Drainage (Northern Ireland) Order 1973 - Schedule 6
Application for consent to undertake works to a watercourse

Your reference:
Our reference: IN1-20-17475

**RE: DRAINAGE ORDER (NORTHERN IRELAND) 1973 – SCHEDULE- 6
APPLICATION TO CULVERT A WATERCOURSE AT BALLYBOGIE
ROAD,ARDMORE.**

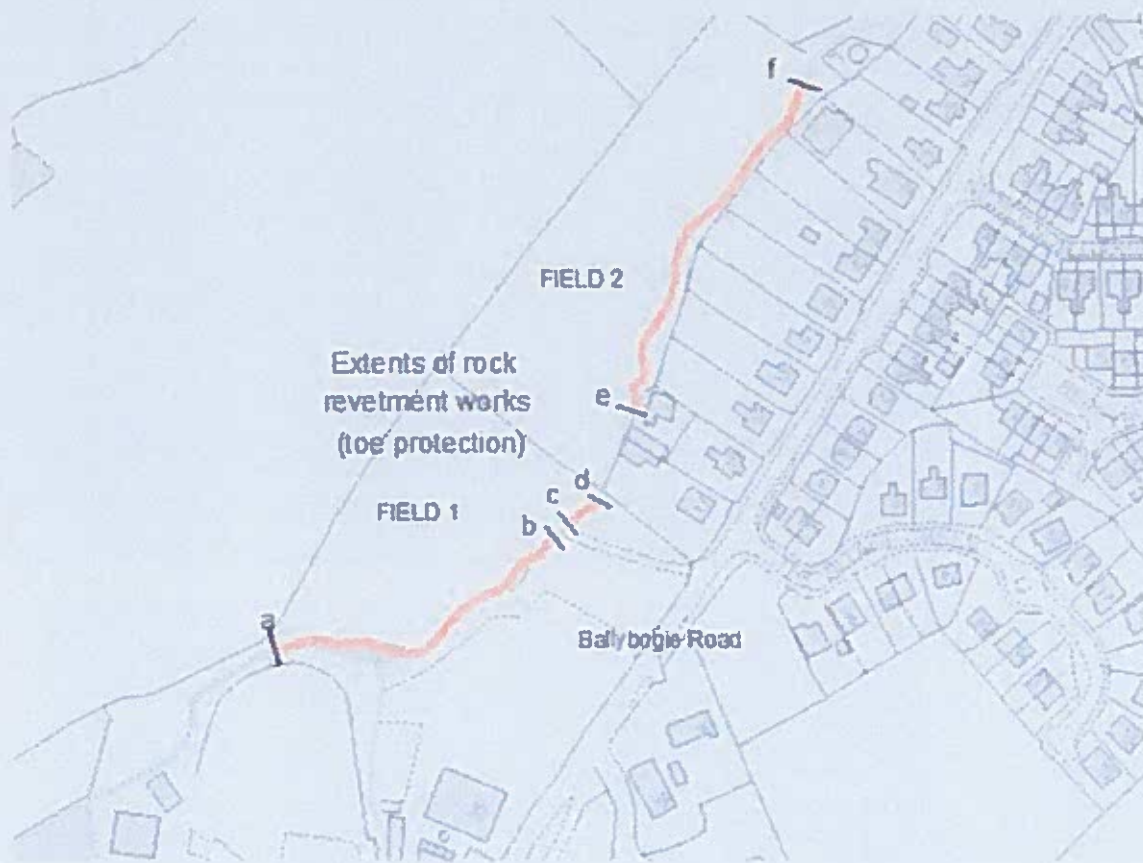
1. Pipes of minimum diameter 1050 mm are required for the culvert as per your application map located at Coordinates [REDACTED]
4. Pipes used to be Class 120 spigot and socket to BS5911-1 2002.
5. The pipes should be laid to a standard of workmanship consistent with their proposed use in relation to bedding, back-filling, jointing etc. I would refer you to the Civil Engineering Specification for Water Industry – 6th Edition, in respect of standards of workmanship recommended.

6. The pipes should be laid to the best attainable uniform gradient and with the invert level a minimum of 150mm below existing firm bed level. When setting invert levels consideration should be given to any future maintenance/development requirements. Manholes/inspection chambers are required at intervals not greater than 60 metres, at any change in direction/gradient or at any junction with existing pipelines.

7. The construction of suitable head walls and wing walls at the culverts inlet is recommended as proposed.

8. Suitable anti-erosion measures must be in place particularly at discharge points.
